LIGO E-TRAVELER

E-Traveler DCC Number & Revision D080251-00-C	Schematic DCC Number & Revision D020241 / D030452	Board Title ISS Intensity Stabilization Servo / ISS Photodiode	Board Serial Number 112
PCB Revision Rev D	Cognizant Design Engineer (COG) Ben Abbott	E-Traveler Originator & Institution Stefan Ballmer	Date May 2, 2008

D020241

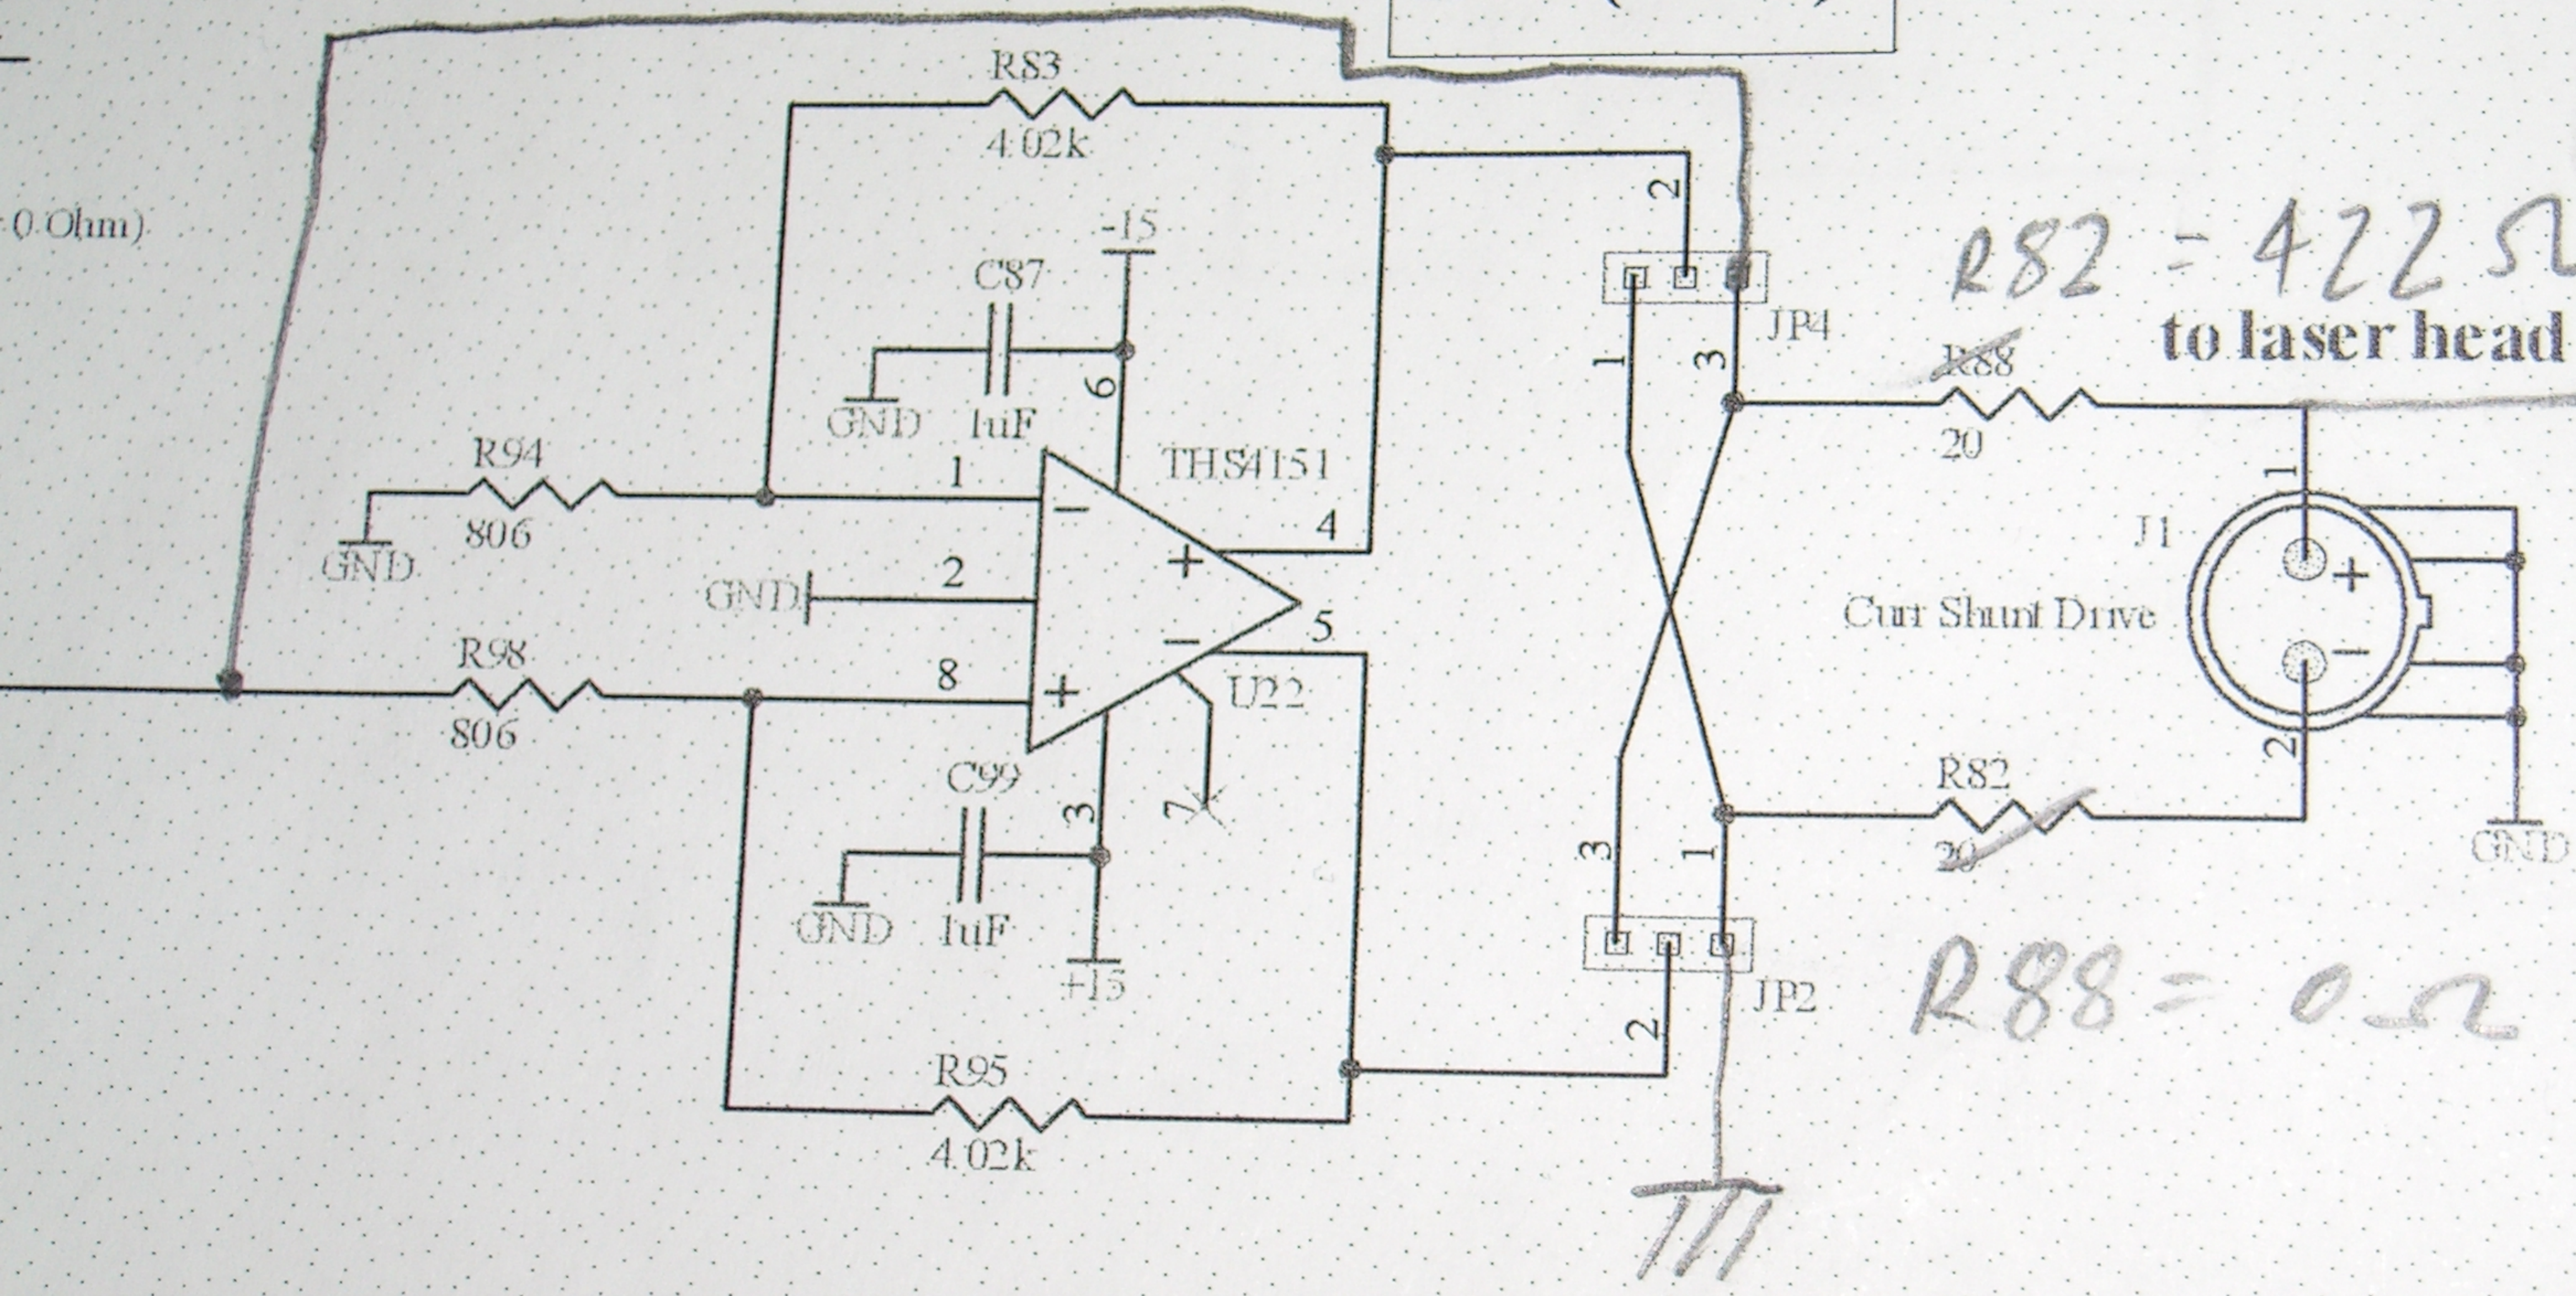
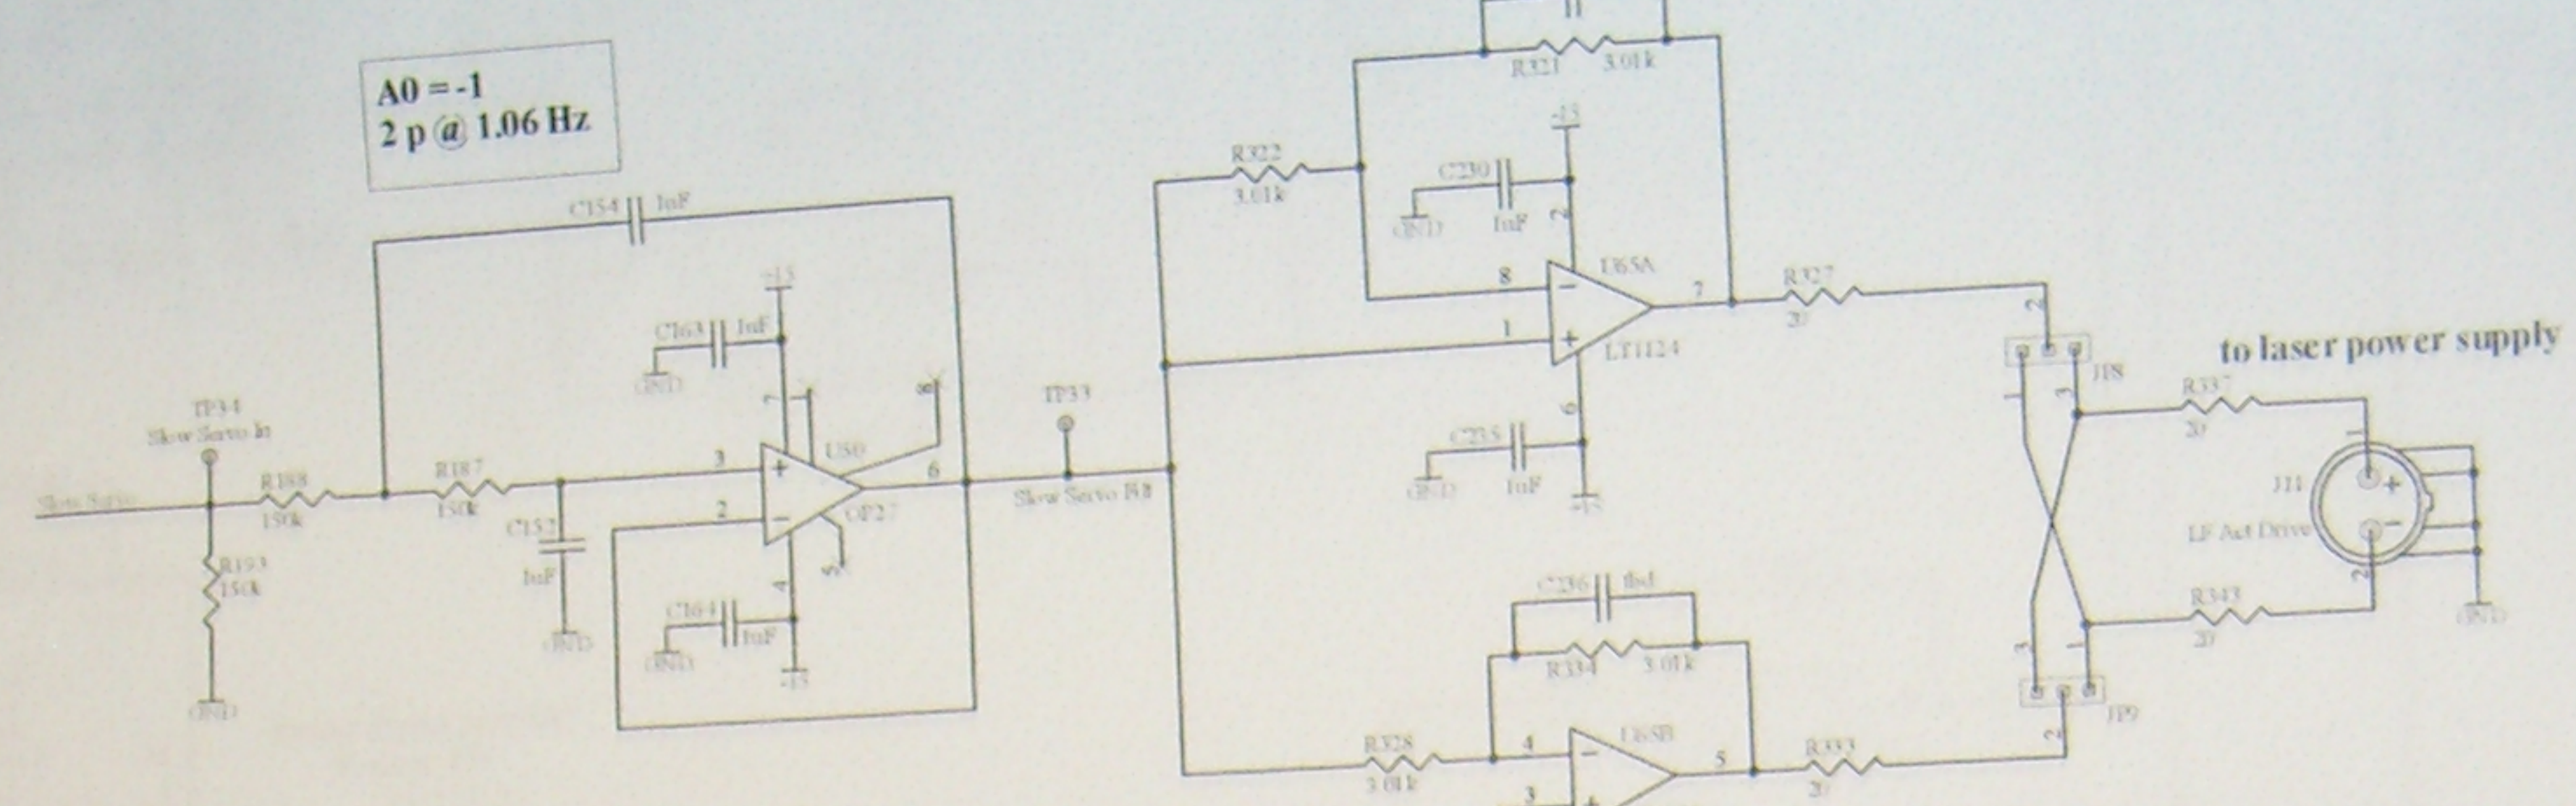
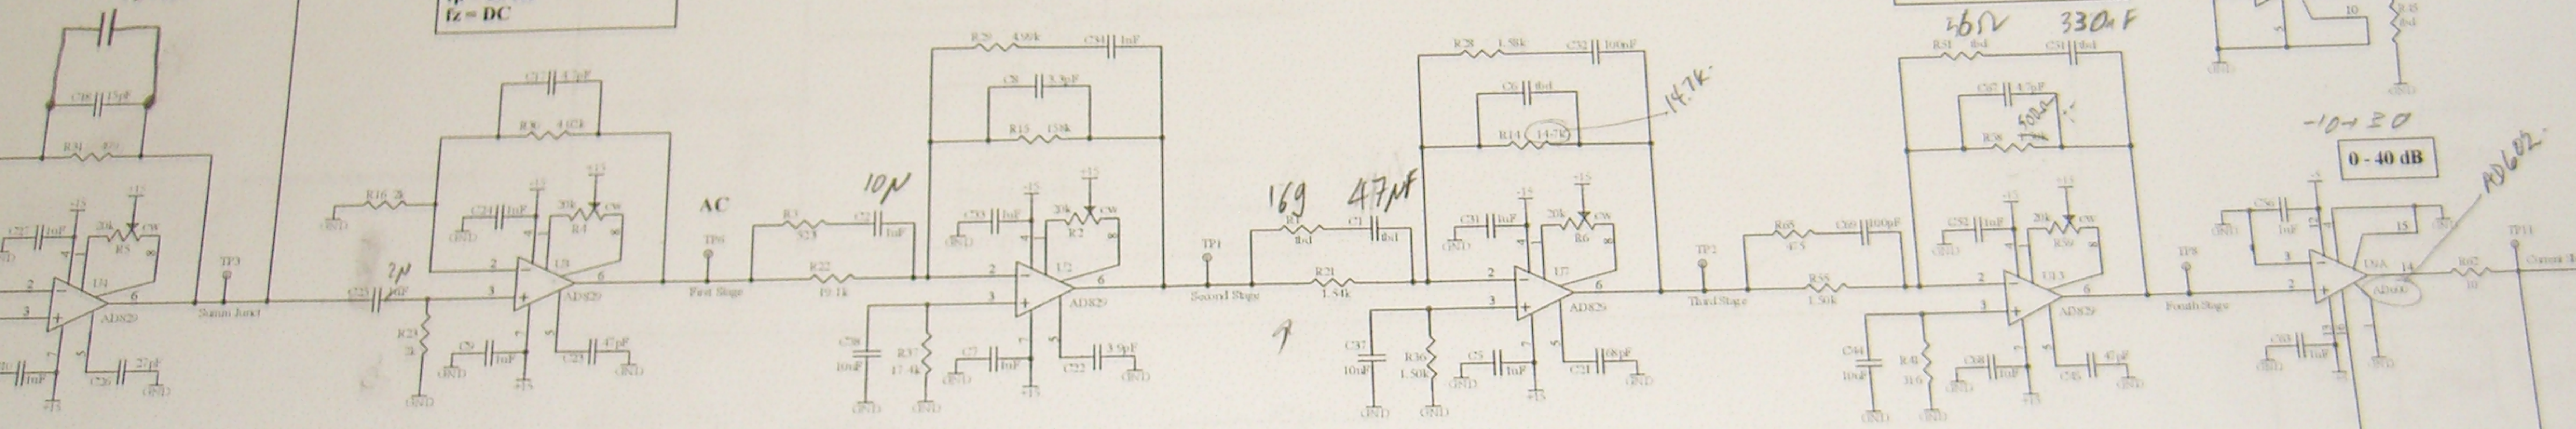
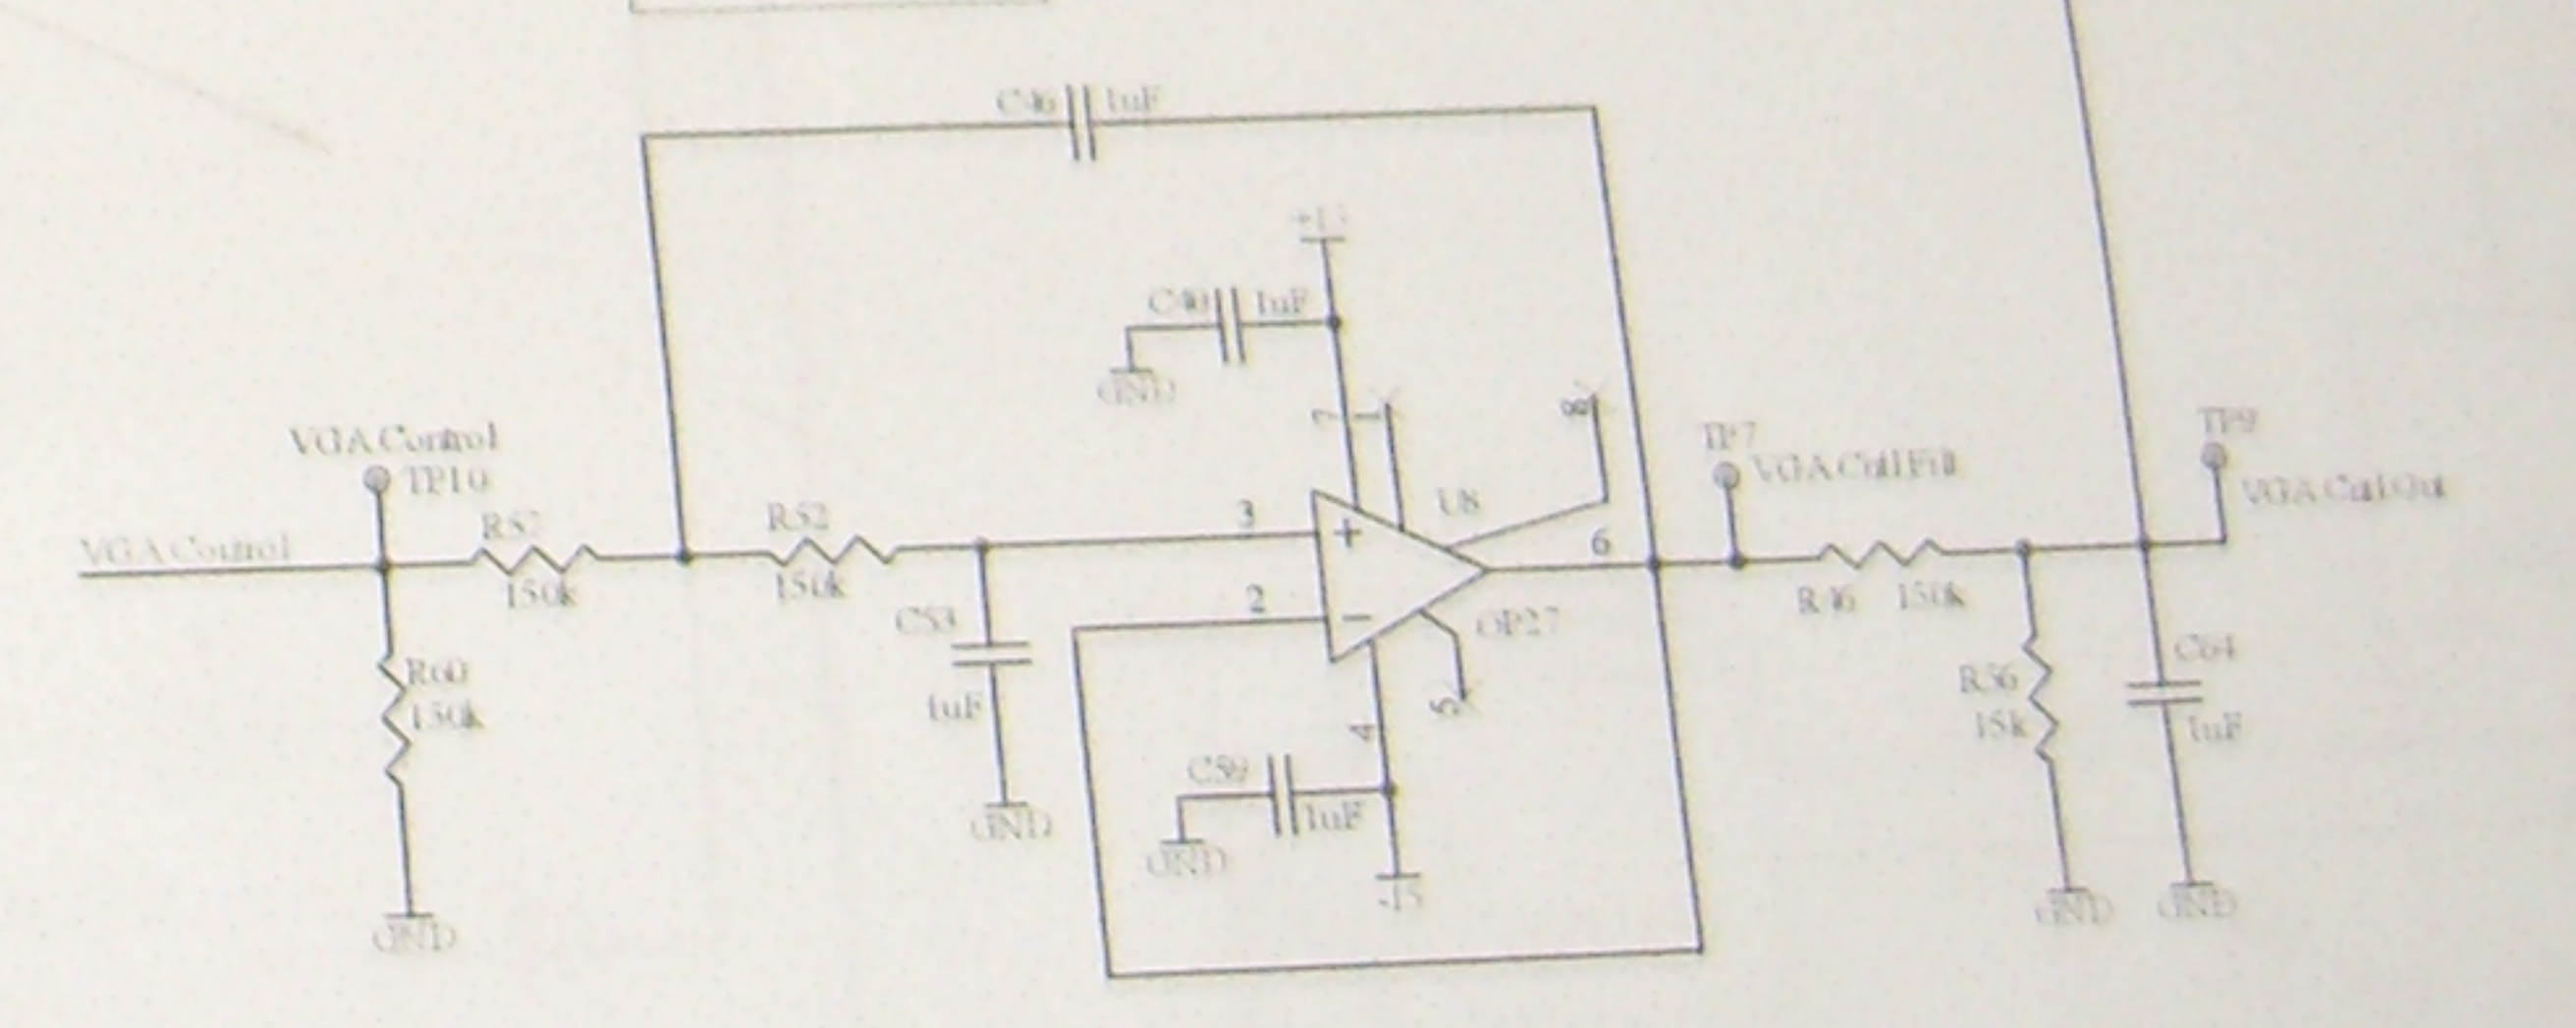
Switched U6, U54, U20, U64 to THS4131.
 Additional 2.1 kHz pole: Added C=150nF in parallel to R31 (499Ohm)
 Lower AC coupling pole by 2: C25 --> 2 uF
 Move pole:zero pair to 10x lower frequency (30Hz:0.8Hz): C2 --> 10 uF
 Add 20Hz:2Hz pole:zero pair: C1 --> 47 uF, R1 --> 169 Ohm, (R21 stays at 1.54k)
 Add 870Hz:8.6kHz pole:zero pair: C51 --> 330 nF, R51 --> 56.2 Ohm, (R58 stays at 499 Ohm)

By-pass U22 and add passive offset network at the output (see picture below). This gives an offset adjust between 0.44 V and 0.64 V.
 TP13 --- 422 Ohm ---x--- 0 to 500 Ohm --- 1 kOhm --- +15V --- 4.7uF --- GND
 |
 ----- to 50 Ohm load (AOM driver)

ISS photodiode (SN 123,124,132,134)
 - Added 10uF in parallel to C4 (total C4=11 uF)
 - Added 100 Ohm resistor in sensing ground line & R3 to 100 Ohm / Ccomp=68pF

$R82 = 422 \Omega$
to laser head

2.1 kHz pole

150 nF

20 Hz
2 Hz
